**Garden City Design Review
Application Review**

**DSRFY2024-0002
34th Street Townhouses**

RESPONSE TO COMMENTS PER ARCHITECT 12/13/2023

DSRFY2024-0002

FRONT ELEVATION - NORTH

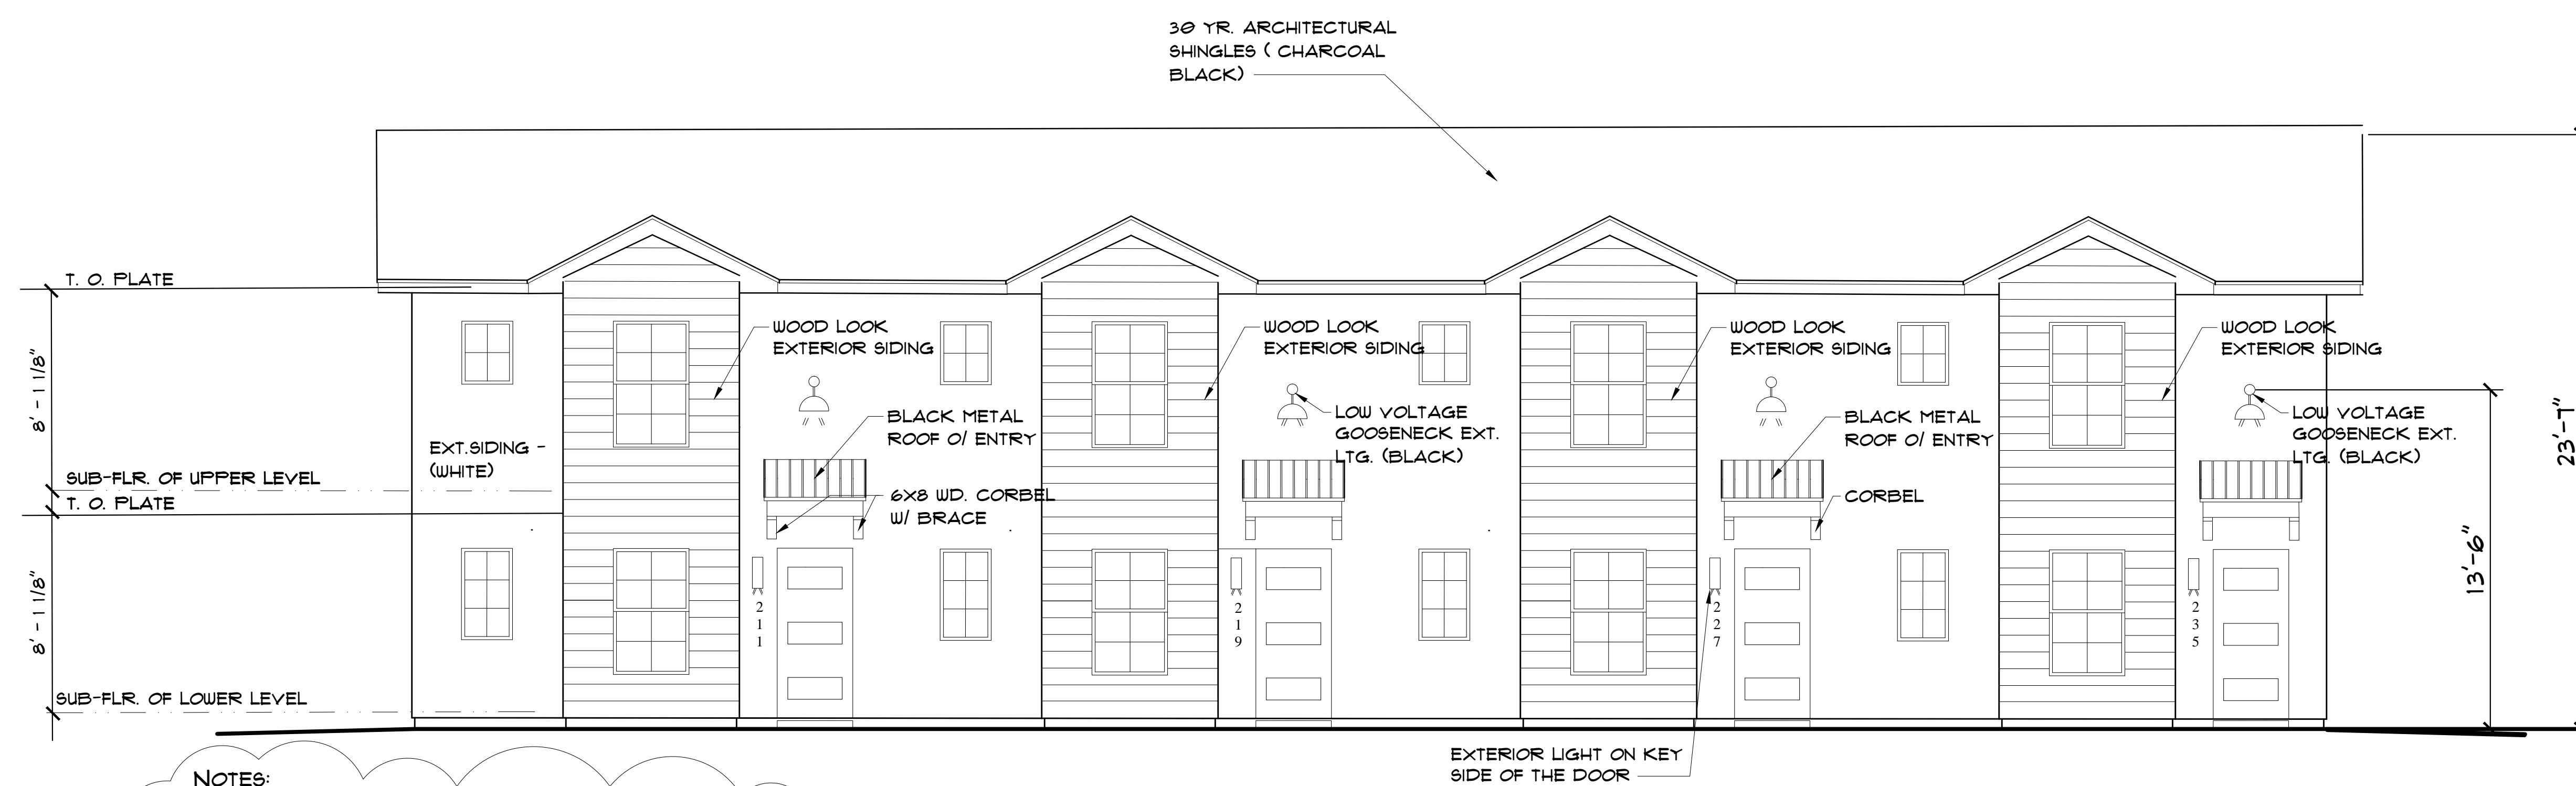
- 1. Parking spaces are not to be located between the public right-of-way and the main building entrance. (8-4D-3)**
- 2. The building is comprised of a single unbroken gable roof from. Consider allowing the gable entry forms to extend above the primary roof eave to provide a distinctive form as viewed from the street.**
- 3. Location of the building relative to the street.**
- 4. Clarify building materials and colors.**
- 5. Confirm location and screening of mechanical, electrical, and communication equipment.**
- 6. Clarify perimeter landscaping provisions per 8-4I-5 are met.**
- 7. Clarity parking lot landscaping provisions per 8-4I-6 are met.**
- 8. Address pedestrian connection of units to the street frontage.**

2. THE DESIGN OF THE FRONT ELEVATION HAS GABLES ABOVE EACH OF THE (4) BUMPOUTS.

4. REFER TO REVISED SUBMITTED ELEVATIONS THAT INDICATE THE BUILDING MATERIALS AND COLORS.

Main Floor Pln.

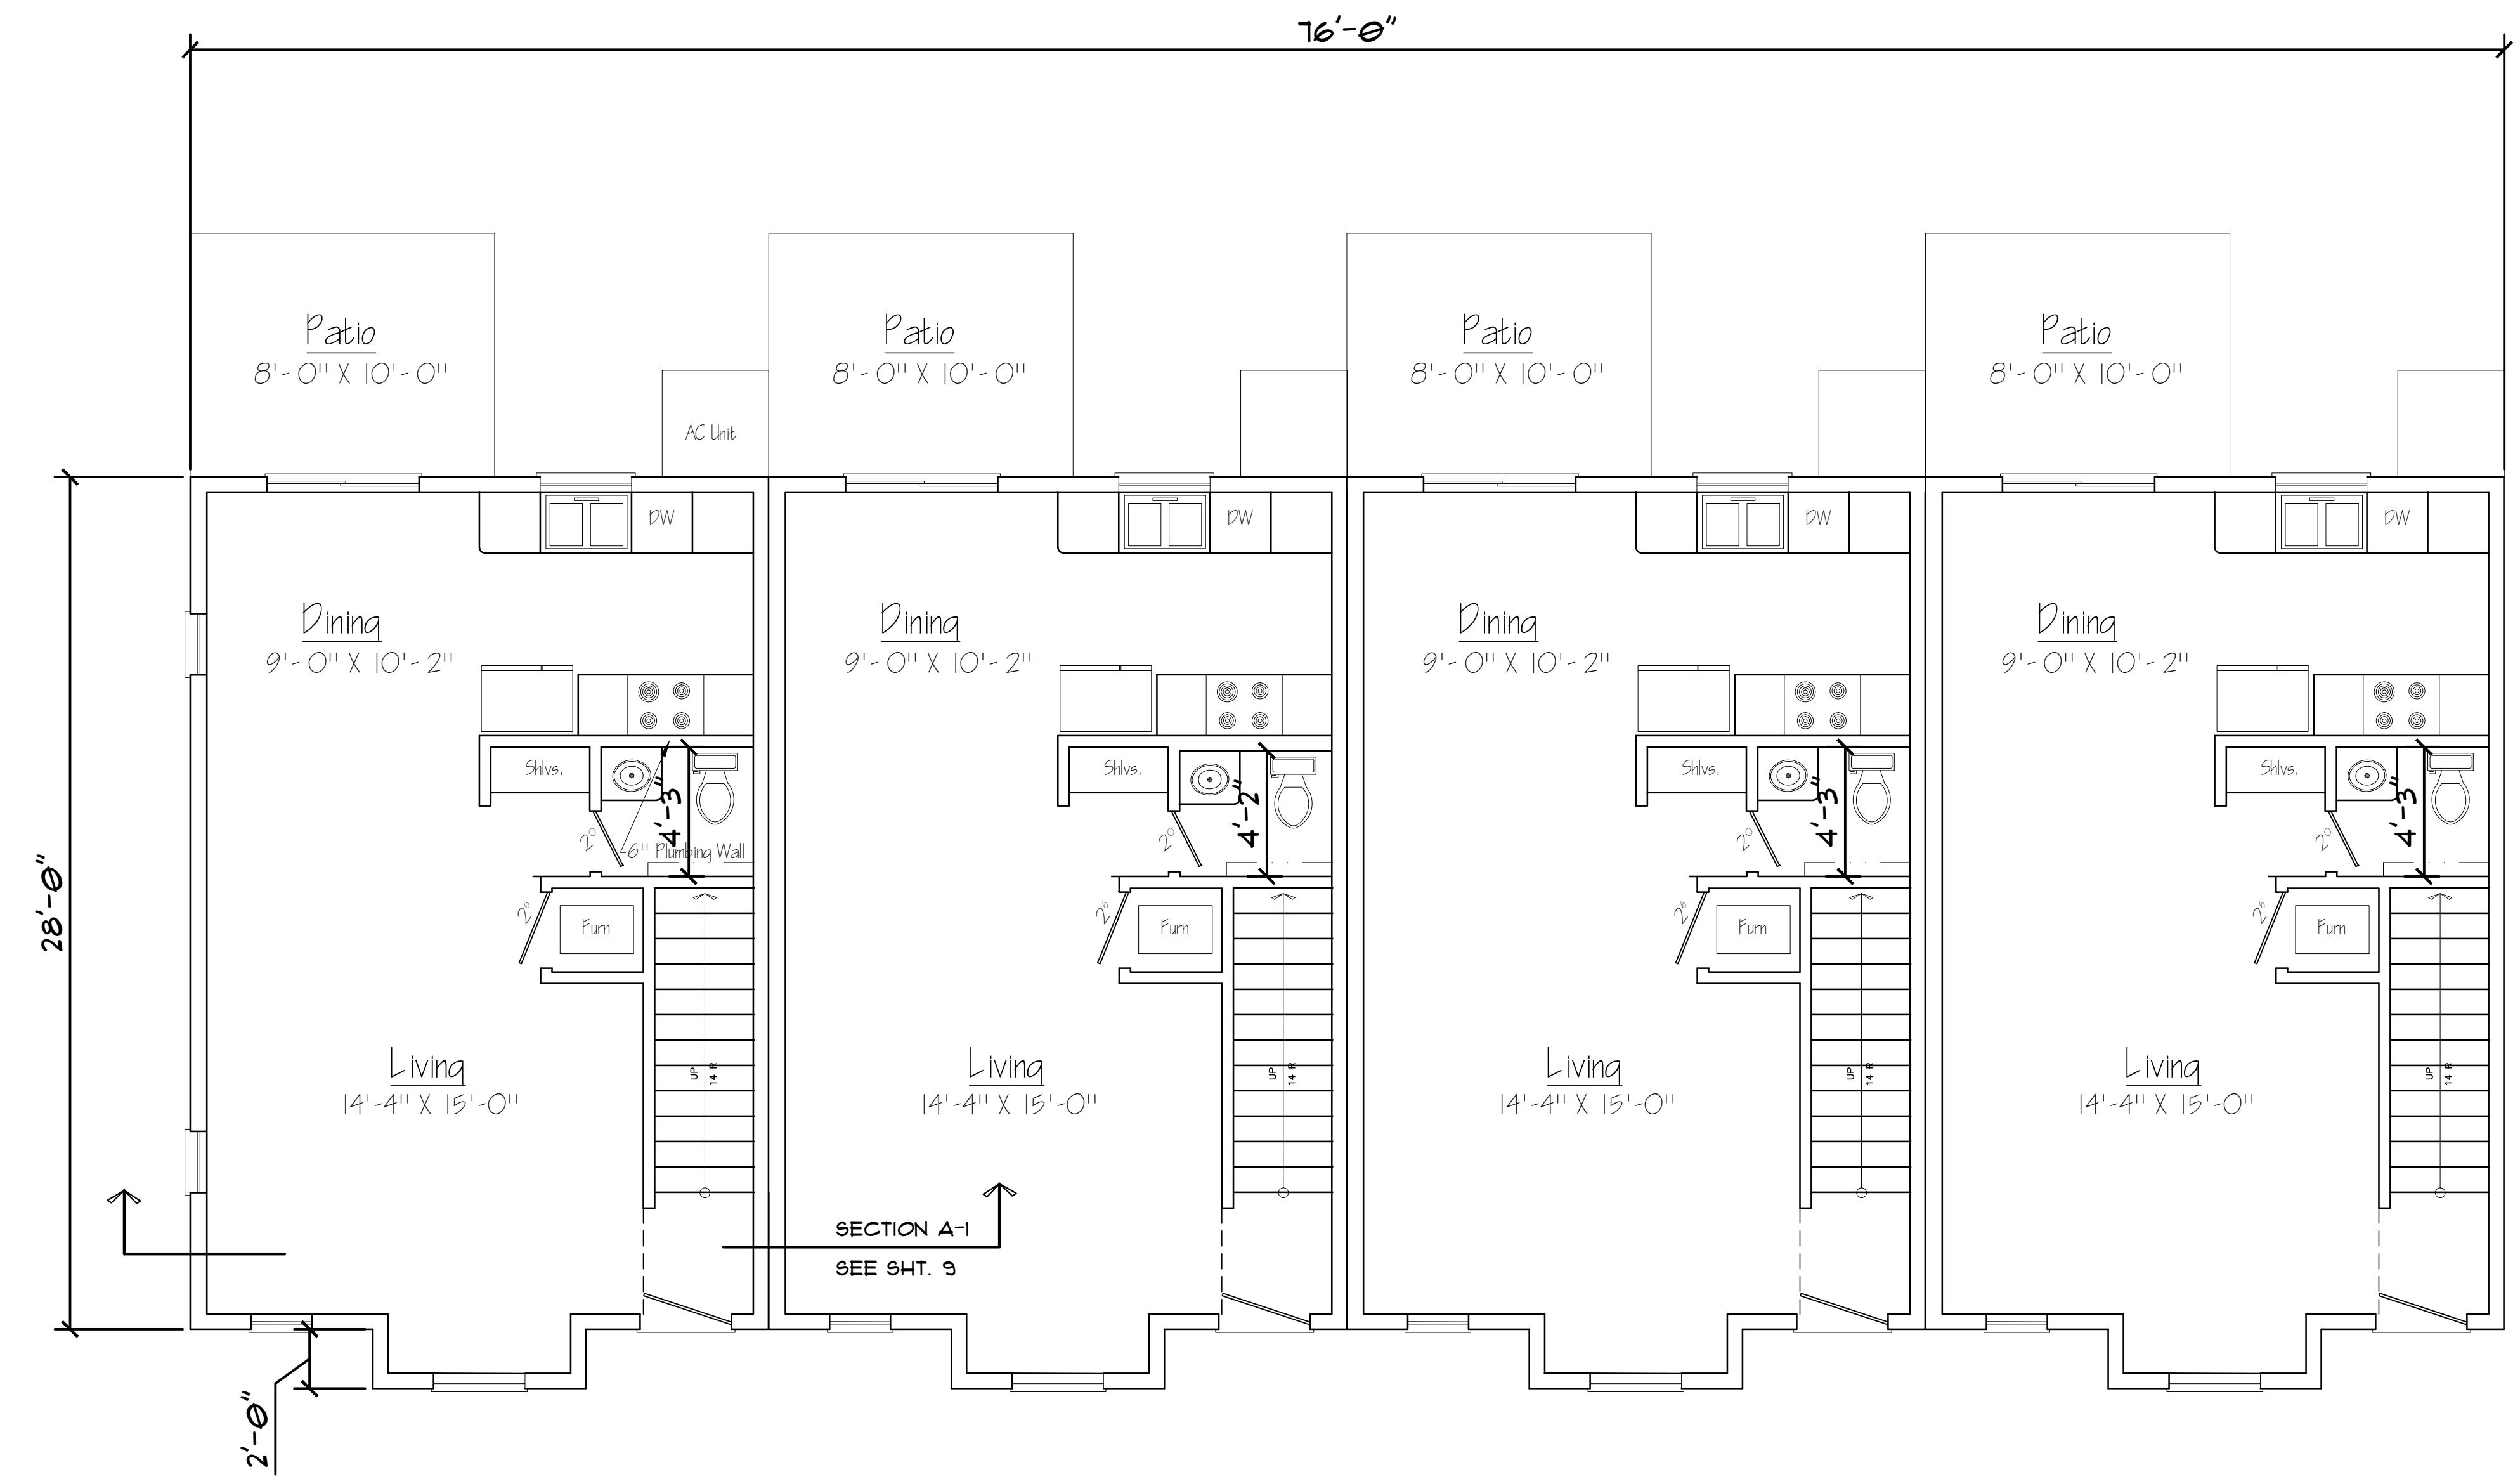
4. **Tree selection – conifers on the street not ideal. Existing spruce tree noted in plan does not appear in street views. Provide Class II & III for street trees.** (COMMENT TO BE ADDRESSED BY LANDSCAPE ARCHITECT.)

5. **Provide projections and articulation on the south, east, and west elevations.** (NOTE PRIVACY WALLS ON S. ELEV.)
6. **Entry roof blocks entry overhead lighting.** (LIGHTING IS PROVIDED NEXT TO EACH DOORWAY ON KEY SIDE.)

4. THERE IS AN EXISTING SPRUCE TREE AT THE EDGE OF THE FRONT PROPERTY IN THE ACHD RIGHT OF WAY.)
5. THE REAR OF THE BUILDING HAS 6' HIGH FENCING AT EACH PATIO THAT PROVIDES ARTICULATION.)
